## **Norwood Young America Planning Commission** 6:00 p.m., Tuesday, April 5, 2022 Norwood Young America City Council Chambers, 310 Elm St. W.

SUBJECT: The Meadows 2<sup>nd</sup> Addition

The Meadows 2<sup>nd</sup> Addition Preliminary Plat Review Project No.: 0C.1126044

Figure 2. Outlot B Absorbed.

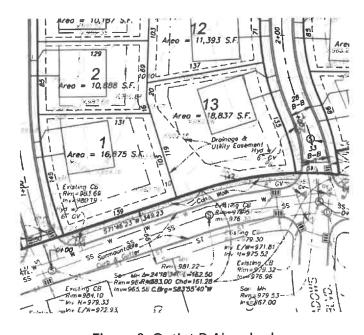
Parkland has been dedicated for The Meadows 2<sup>nd</sup> Addition under the existing development agreement from 2005. This existing parkland is noted as Outlot B, which occupies the entire east side of the development. In the concept plan resolution dated February 14, 2022, a new Outlot B, abutting single-family Lots 1 and 13 has been dedicated. The preliminary plat submitted shows Lots 1 and 13 absorbing Outlot B (Figure 2). The City did not wish to maintain this new outlot and will not require parkland dedication fees.

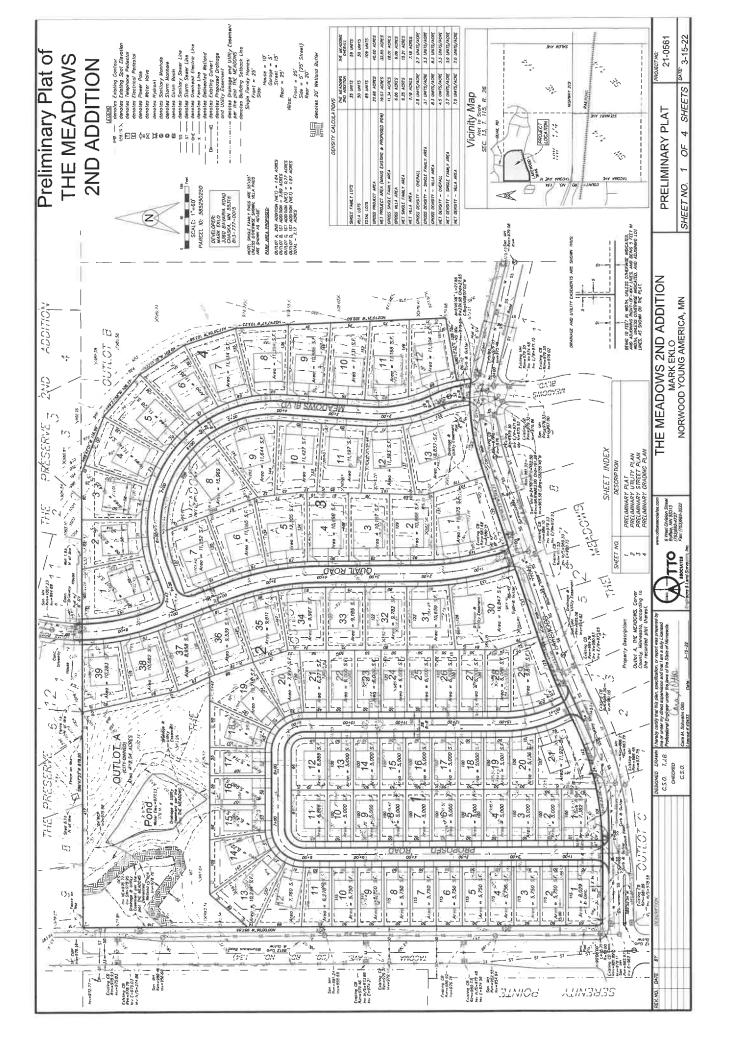
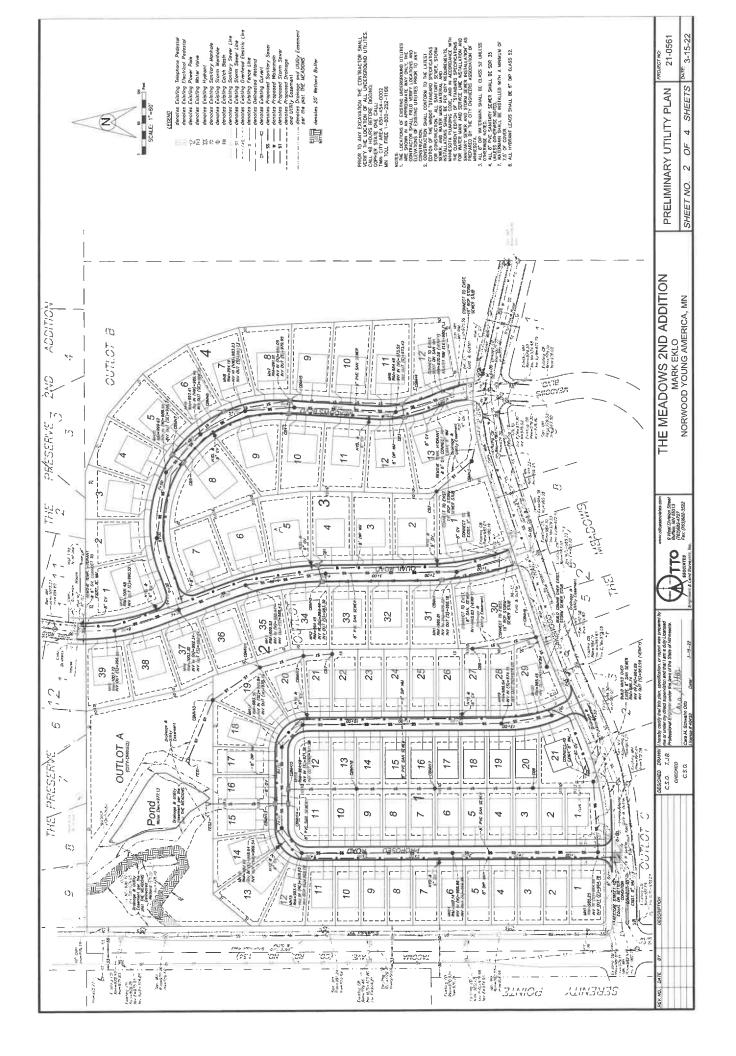
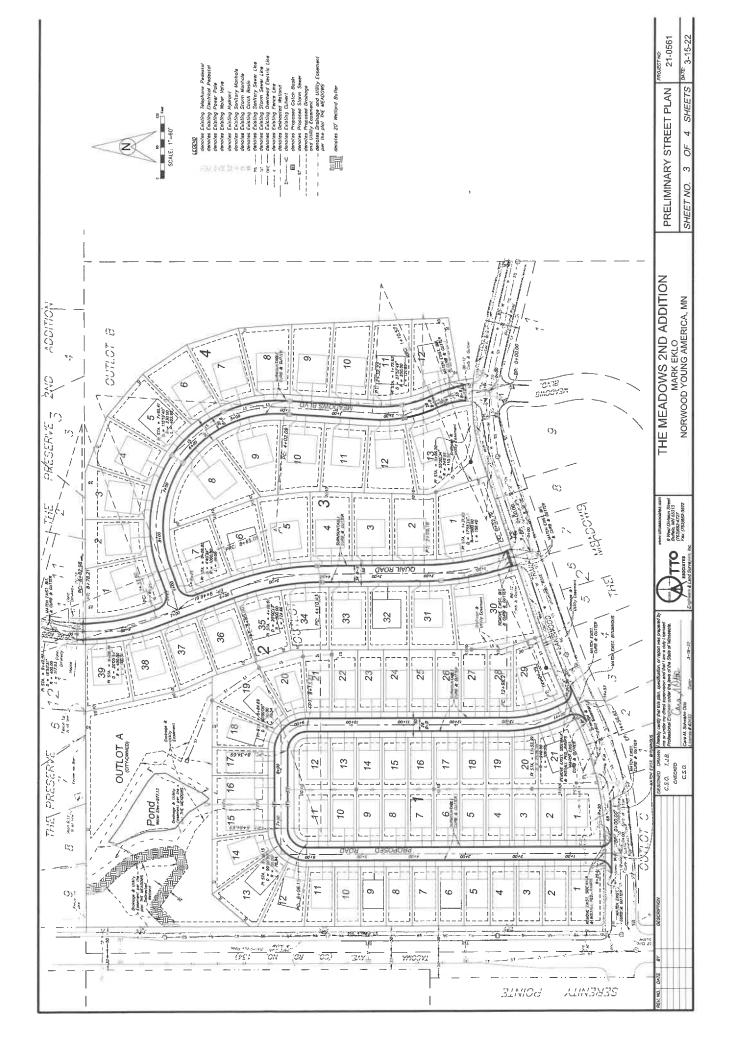
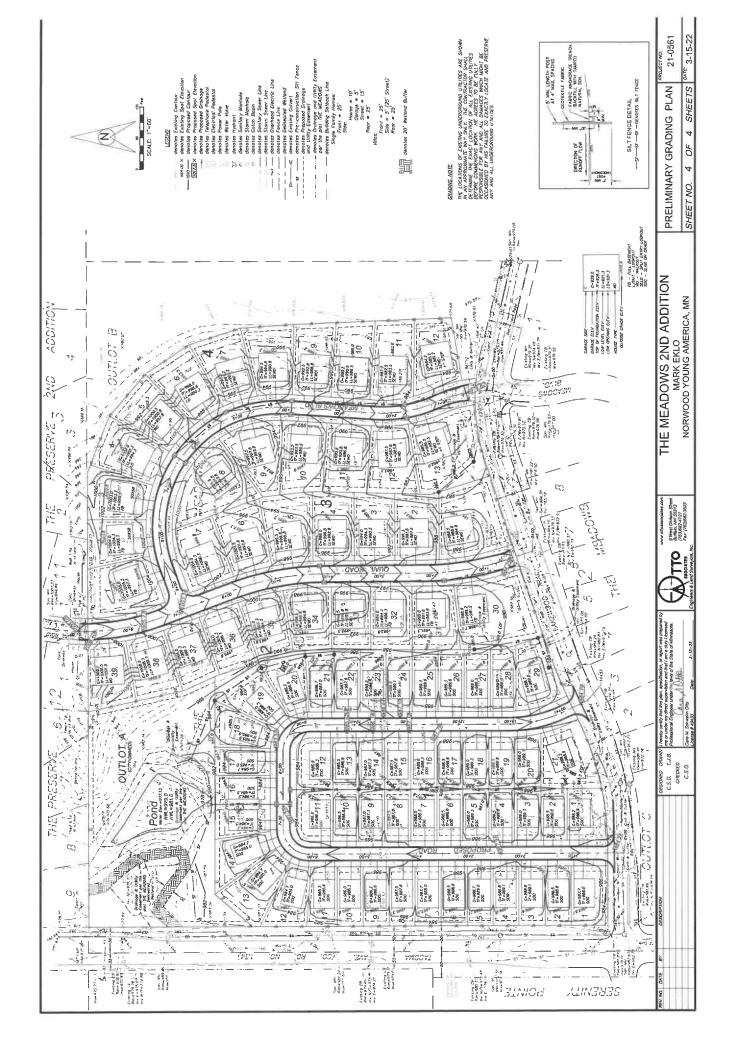
- 1) The submitted preliminary plat appears to be generally consistent with previous concept plans for the project area.
- 2) This review assumes the streets, sanitary sewer, watermain and storm sewer facilities will be owned operated and maintained by the City. If this assumption is incorrect, additional review comments may be appropriate.
- 3) City Standard Details shall be included in the final plans for all public improvements, including but not limited to streets, sanitary sewer, watermain, storm sewer, tracer wire, etc.
- 4) Several permits are required for the proposed improvements, including but not limited to MPCA sewer extension, MDH watermain extension, NPDES, CCWMO, etc. Copies of all permits shall be submitted for the project files prior to construction.
- 5) The submitted information should be submitted to CCWMO and the Fire Chief for review and comment.

- 1) Quail Road is proposed as a 34-foot-wide public street with 50-foot Right of Way. This is acceptable from an engineering perspective. Meadows Blvd and "Proposed Road" are proposed as 28 feet wide with 50-foot Right of Way. It is assumed these streets are intended to be public.
- 2) There are no other 28-foot-wide streets in this development. If 28-foot-wide streets are allowed, it is recommended parking be allowed on one side only, and appropriate signage be placed by the Developer during construction.

- Sanitary sewer and storm sewer manholes shall be added to avoid sanitary sewer and watermain located under the curb, and watermain located under the storm sewer to the extent practicable.
   Manholes shall be located on centerline of the street, or the center of the traveled lane. This can be completed during design.

- 2) Final hydrant locations and valving can be determined during design.
- 3) Gate valves shall be located at the connection point of all existing watermains.

- 4) Gate valves should be added north and south of the tee at Meadows Blvd and Quail Rd.
- 5) The connection to existing watermain at the south end of Block 1 should be modified to eliminate the existing dead end and plug.

- 6) A manhole will be required at the connection to existing sewer on Quail Road for testing purposes.
- 7) It appears excavation into Lakewood trail will be required. Pavement shall be restored to the section in place. A traffic control plan shall be submitted with final plans. The disturbed surface should be open to traffic with an aggregate surface at the end of each day.

- 1) Stormwater ponding was completed in previous phases of the overall development. Verify the hard surface coverage is equal to or less than that planned in the original design. CCWMO Rules have changed, as such on site water quality measures may be required by CCWMO.
- 2) Storm sewer calculations, with a corresponding drainage area map, shall be submitted with final design plans.
- 3) Pond, swale, and easement area grading shall be revised accordingly as noted herein for operation and maintenance accessibility. Access shall be provided for all ponds, swales and public utility encumbering D/U's. Access locations should be shown on the plan.

- 4) The plans indicate several areas with rear yard swales. Additional storm sewer and drain tiles, including sump pump discharge connections may be required in these locations, to ensure proper site drainage and sump pump discharge handling. This can be determined during design.

- 1) D/U easements over proposed public utilities (sanitary sewer, storm sewer, and watermain), shall have a minimum width of 1:1 from pipe invert to finished ground elevation, on each side of the pipe, plus 5'. (Example: utility at 10' deep, easement width = 25', 12.5' each side of the pipe). In addition, it is recommended the minimum D/U easement width over proposed utilities be 20', regardless of pipe depth, to provide access for operation and maintenance activities. This includes along Tacoma Avenue and Lakewood Trail.

- 2) D/U easements encumbering ponds and drainage swales shall be a minimum of 10' wider than the HWL and encumber an access area with a maximum slope of 4:1 from HWL to easement limit around the entire pond, and on a minimum of 1 side of drainage swales, to provide access to ponds and swales for operation and maintenance activities.
